TO: Planning Commission **Agenda of:** June 25, 2009

RE: DR00-0011/76 Gas Station & Circle K Mini Mart

CORRECTIONS TO THE FINAL EIR

SMITH ENGINEERING & MANAGEMENT

Figure 2.0-1
RV Turn Radius Entering From South Shingle Springs Road
PMC

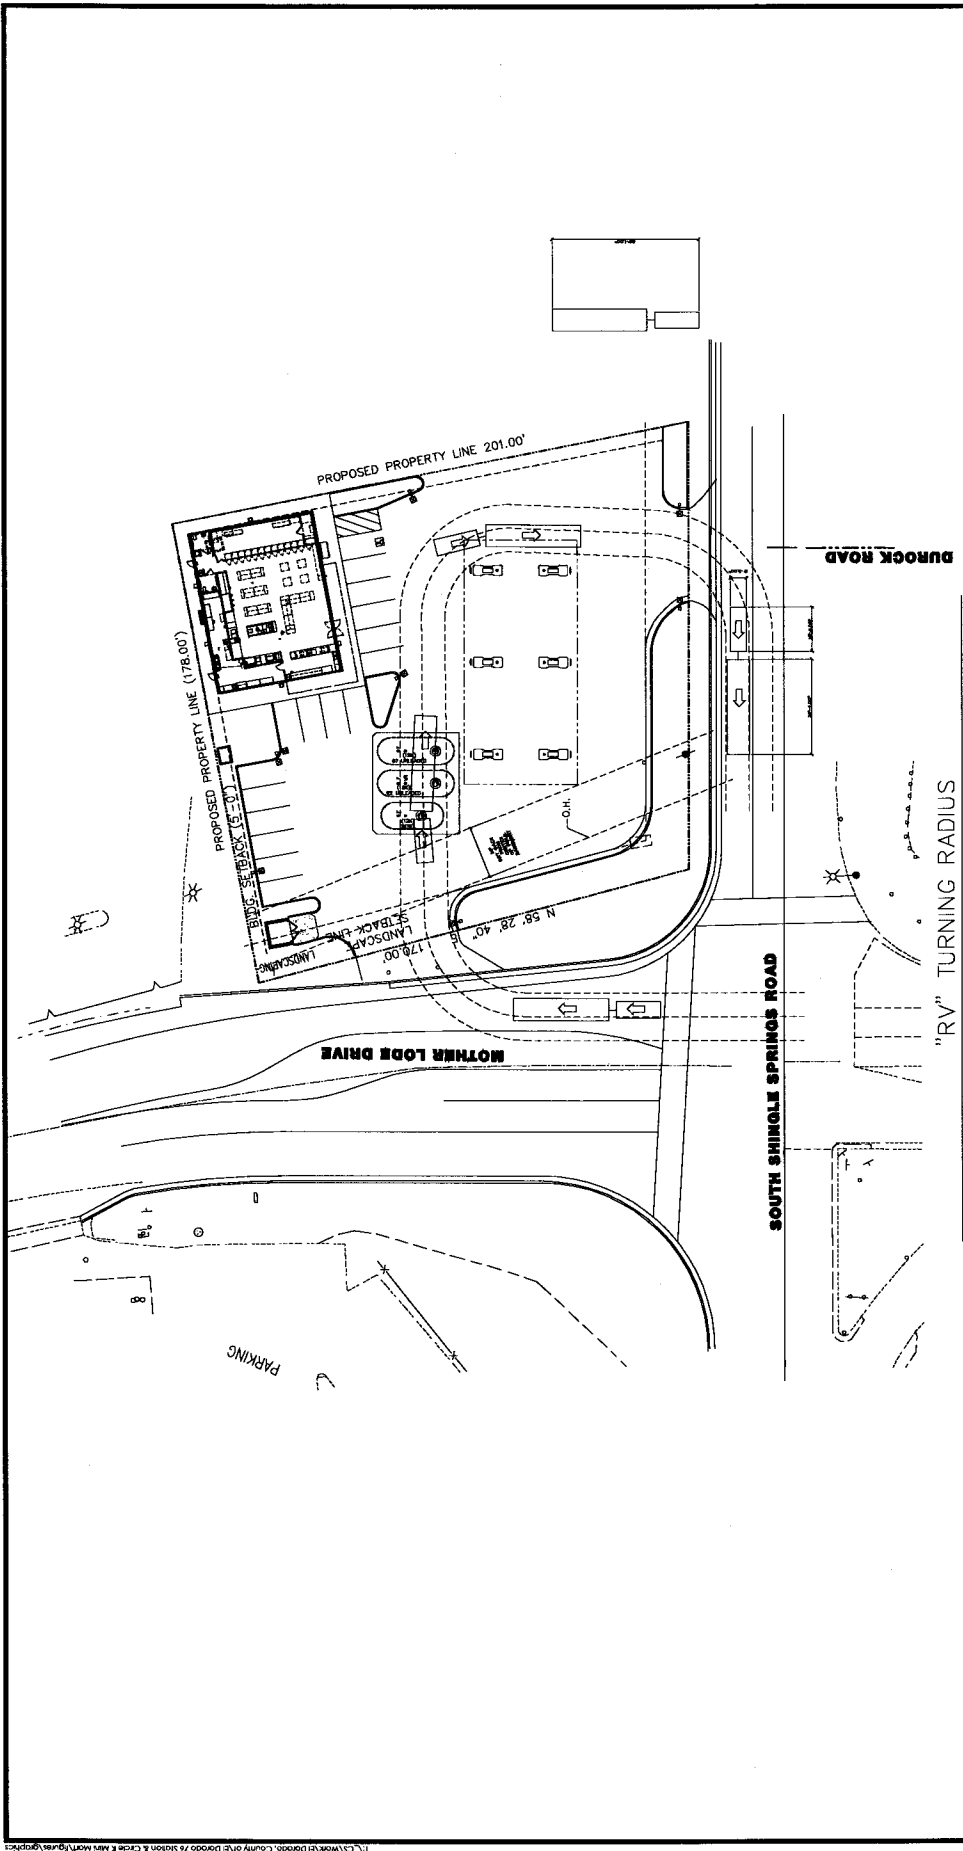
Dan Smith Letter Page 7: “. . . the FEIR response cites FEIR exhibits **Figures 2.0-1 2.0-2 and 2.0-3**. However, these critical pieces of evidence are nowhere to be seen in the FEIR as circulated. Because of the missing Figures 2.0-1 2.0-2 and 2.0-3, the FEIR is deficient as an information document and cannot be certified.”

The response, citing use of an updated site plan and a different source of turning templates (ones that we acknowledge are also authoritative) than those relied on in the comments, claims that the site is fully navigable by the most critical vehicle combination to visit the site. In attempting to demonstrate its conclusion, the FEIR response cites FEIR exhibits **Figures 2.0-1 2.0-2 and 2.0-3**. However, these critical pieces of evidence are nowhere to be seen in the FEIR as circulated. Because of the missing Figures 2.0-1 2.0-2 and 2.0-3, the FEIR is deficient as an information document and cannot be certified.

The absence of missing Figures 2.0-1, 2.0-2 and 2.0-3 makes it impossible to fully evaluate the response. However, we note that in many instances the response a) admits the constraint we identify but claim the constraint is commonplace at some gas stations, b) admits the constraint but claims it can be overcome by undesirable multi-part maneuvers, or c) admits the constraints exist but claims that drivers will overcome it by using an easier to access or egress fueling position. In one instance, the response indicates that the constraint can be overcome by the obviously hazardous maneuver of backing into the driveway. In another instance, the response indicates that the constraint can be overcome by making a tortuous U-turn across the south portion of the site to exit via the driveway of entry – a maneuver that would freeze most maneuvers on or entering the southern portion of the site while it was being completed. While the response in some way speaks to every constraint identified in the comments, it does not address the cumulative condition that emerges from these constraints. That

- b. After page 2.0-120, **Figures 2.0-1, 2.0-2, 2.0-3 and 2.0-4** are added to the Final EIR.
